Amendments to the Drawings:

Application No. 10/569,167
Preliminary Amendment

Fig. ~~6~~⁵

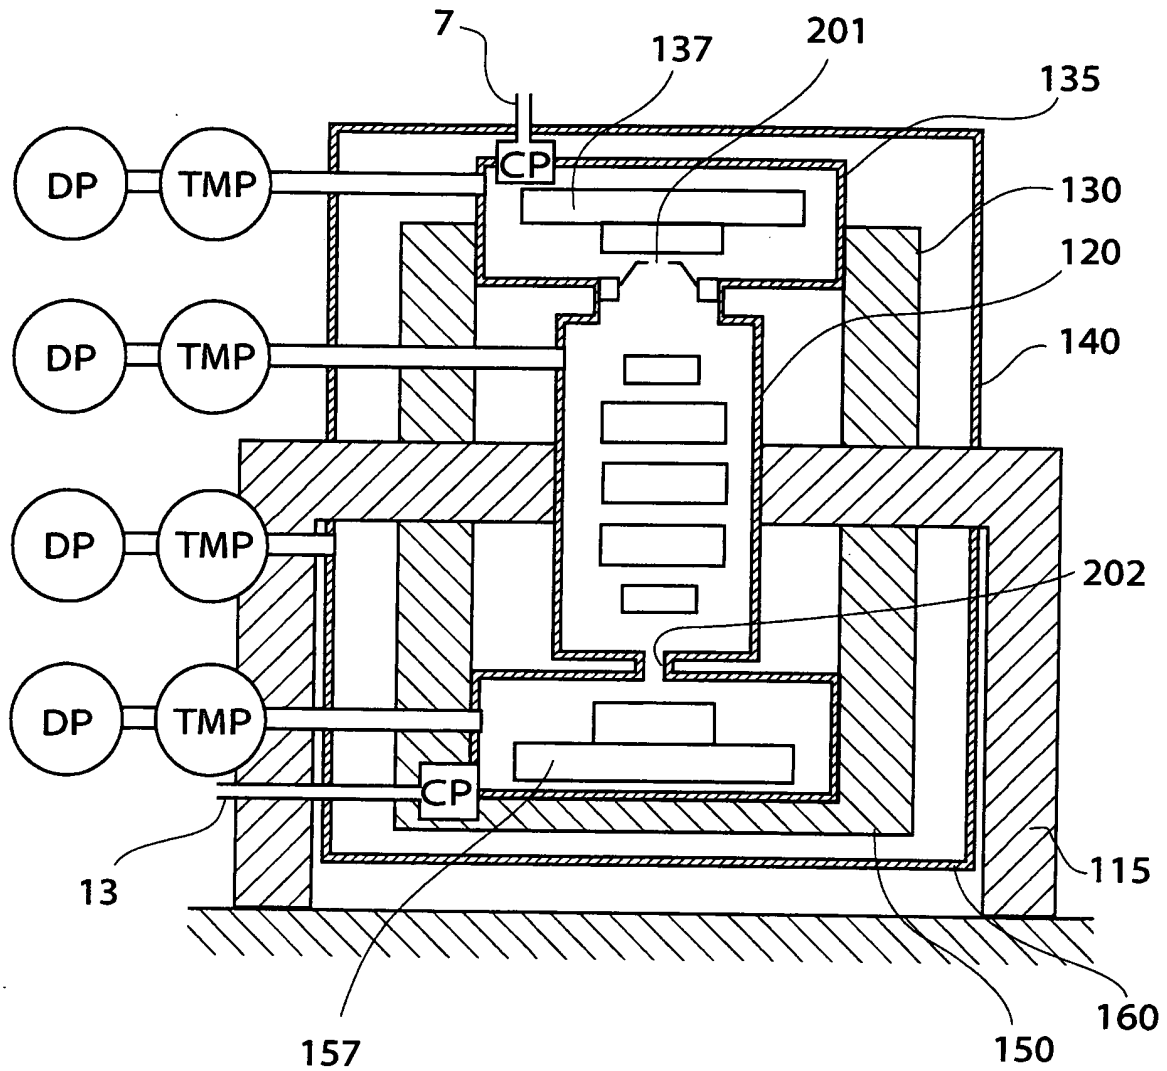
1. Re-label Fig. 5 as -Fig. 6--; and
2. Re-label Fig. 6 as -Fig. 5--.

The drawings have been amended to re-label Figs. 6 and 5 as --Figs. 5 and 6--, respectively. This correction is supported by the description in the original disclosure. See, for example, the description in the English language translation on pages 26-30. The various descriptions of Fig. 5 in the specification clearly relate to original Fig. 6 (re-numbered as Fig. 5), and the various descriptions of Fig. 6 in the English language specification clearly relate to original Fig. 5 (re-numbered as Fig 6). See also, for example, the description including the "cryo pump CP" at page 26, line 13 of the English language specification. The cryo pump CP is shown in original Fig. 6 (re-labeled as Fig. 5).
